**Re: GE-Pittsfield/Housatonic River Site  
Unkamet Brook Area (GEC170)  
Third Supplement to the Pre-Design Investigation Report for Unkamet Brook Area  
Removal Action**

GENERAL ELECTRIC COMPANY  
 PITTSFIELD, MASSACHUSETTS  
**THIRD SUPPLEMENT TO THE PRE-DESIGN INVESTIGATION  
 REPORT FOR UNKAMET BROOK AREA REMOVAL ACTION**

FIGURE  
**E**

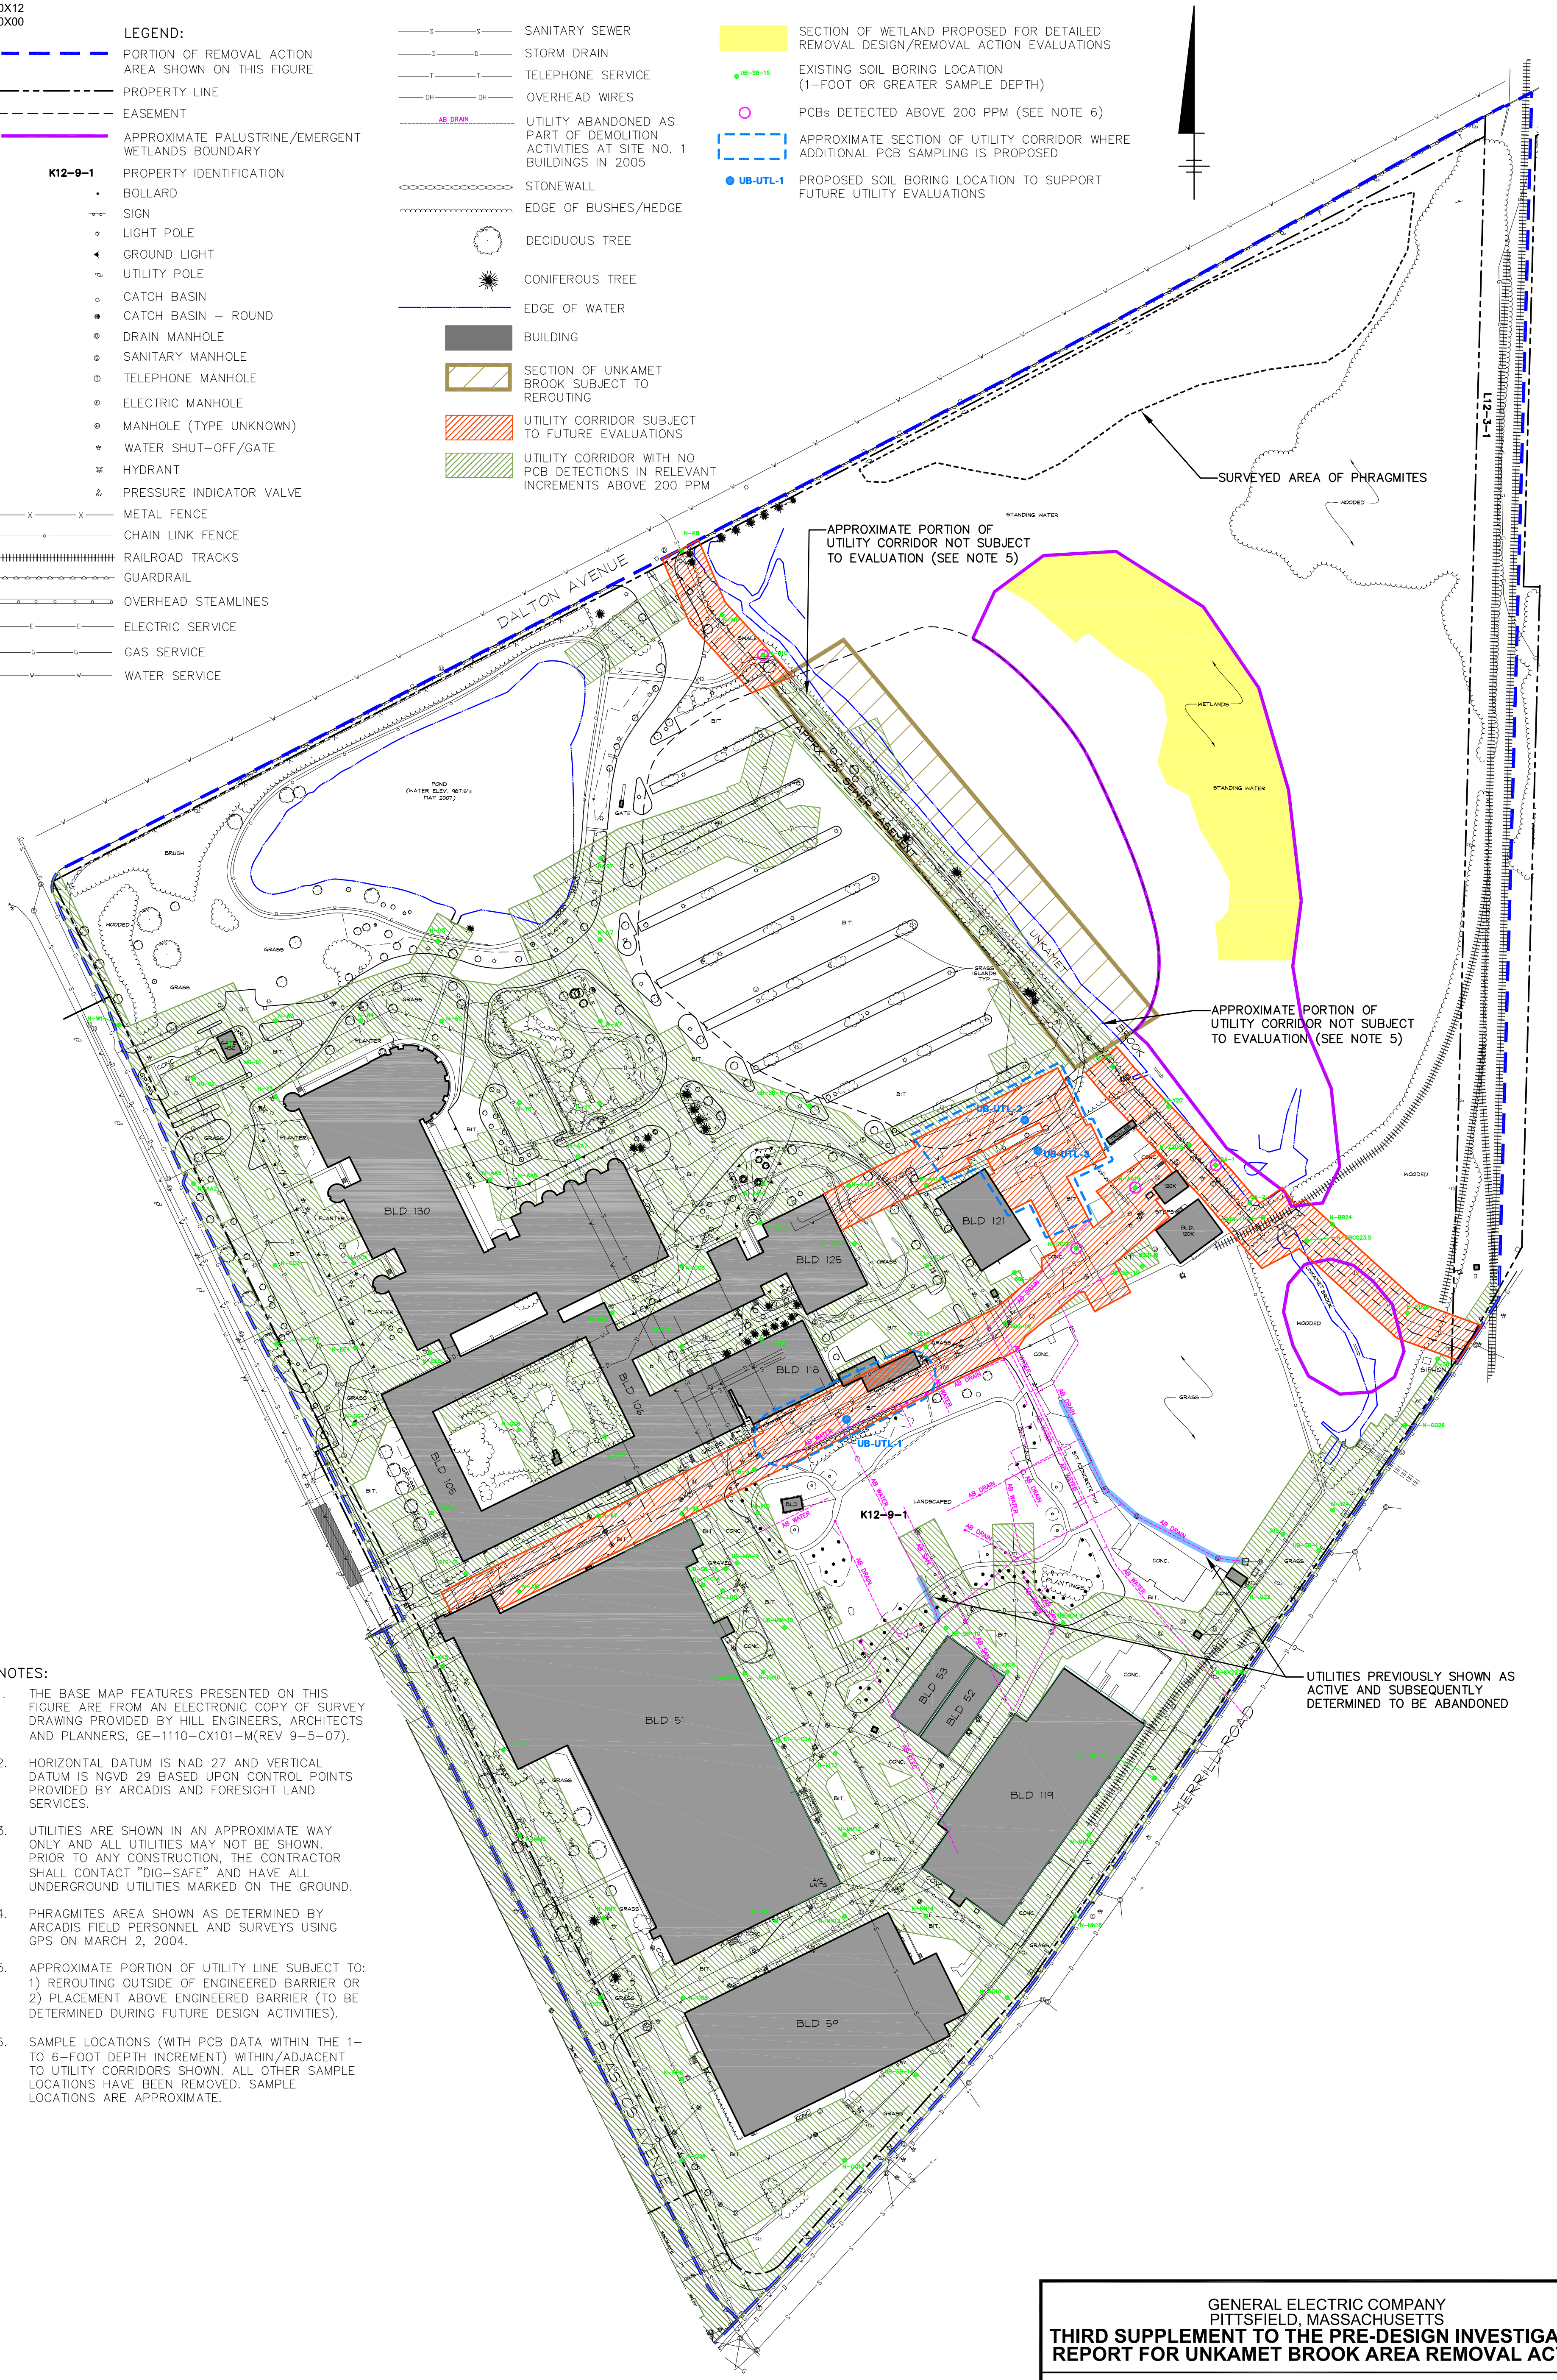
EPA Condition 3 – *Figure 3 from GE's 2005 Decommissioning and Demolition Summary Report shows utilities within the landscaped area that are not represented in Figure E of the Second Supplement. GE shall revise Figure E to accurately represent all non-abandoned utilities and utility corridors and, if necessary, propose any additional sampling necessary to characterize the utility corridors. GE shall also identify all abandoned utilities in the areas and document how they were abandoned.*

GE Response – Between March and September 2005, GE conducted demolition activities within the above-referenced landscaped area. Demolition activities were summarized in a document titled *Decommissioning and Demolition Summary Report Site No. 1* (Demolition Report). A copy of the Demolition Report was provided to EPA on March 25, 2008. As described in that report, utilities within and adjacent to the demolition area were abandoned prior to initializing demolition activities. Fire suppression and water service lines were appropriately capped. Drainage and sanitary sewer connections within buildings subject to demolition were cut flush with first floor slabs. All abandoned

drainage and sanitary sewer lines were subsequently filled with concrete. In addition, the abandoned electric supply line was terminated in Building 119. In response to Condition 3, Attachment C contains a revised Figure E. This revised figure shows both existing and abandoned utilities. It should be noted that no corridors are shown for the abandoned utilities as they are no longer in service and would not be subject to future emergency repair.

Upon review of Figure 3 from the Demolition Report, it was determined that two utility lines that had previously been shown as existing and active were in fact abandoned during the Site No. 1 demolition activities. These lines are highlighted in blue on the revised Figure E provided in Attachment C. Accordingly, Table 4 from the Second Supplement has been revised (also included in Attachment C), by removing samples that do not fall within corridors associated with existing and active utility lines. Specifically, PCB analytical results associated with sample locations N-GG18, N-II20, UB-SB-2 and UB-SB-19 have been removed from the previous version of Table 4 included in the Second Supplement.
